Minute No. 674
Report – Standing Policy Committee on Property and Development – July 8, 2014

Item No. 5 **Secondary Plan – Area Bounded by Gunn Road, Perimeter Highway, Transcona Trail and Central MB Railway (to establish Transcona North Precinct Plan – Precinct "I")**
File SP 6/2013

1. That By-law No. 1/2014, the Transcona North Precinct Plan, be forwarded to Council for second and third reading with the following alterations:

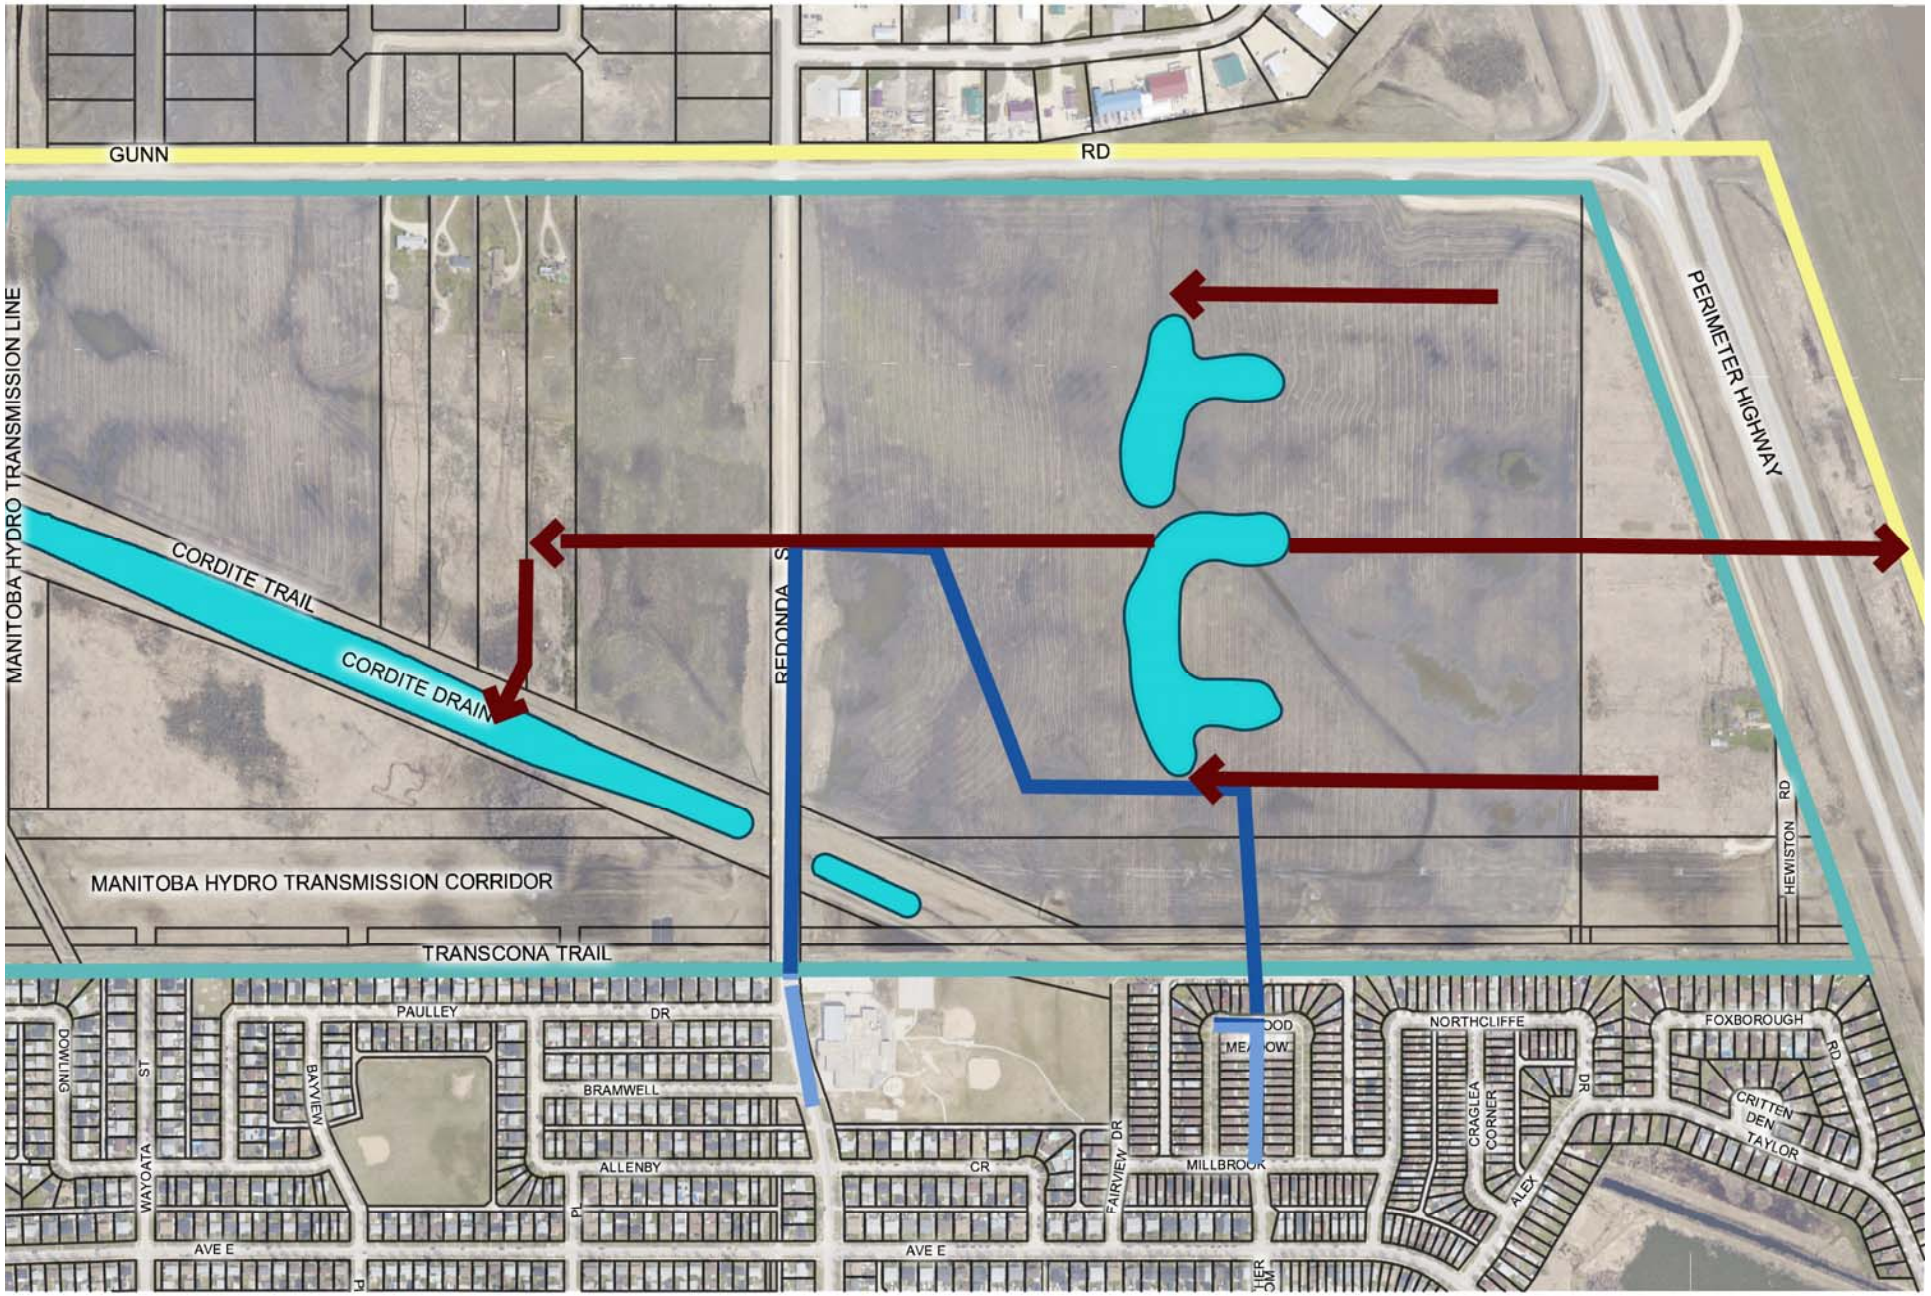
K. That Figure 8: 'Municipal Trunk Services' be replaced with the map included as 'Item 7' of Appendix 'B' and renumbered to 'Figure 9' and that all references to Figure 8 be altered to Figure 9 accordingly.

"(d) The stormwater management system for the precinct area may include additional storm retention ponds not depicted in Figure 9 (Municipal Trunk Services). The location and size of such facilities will be determined at the development application stage."
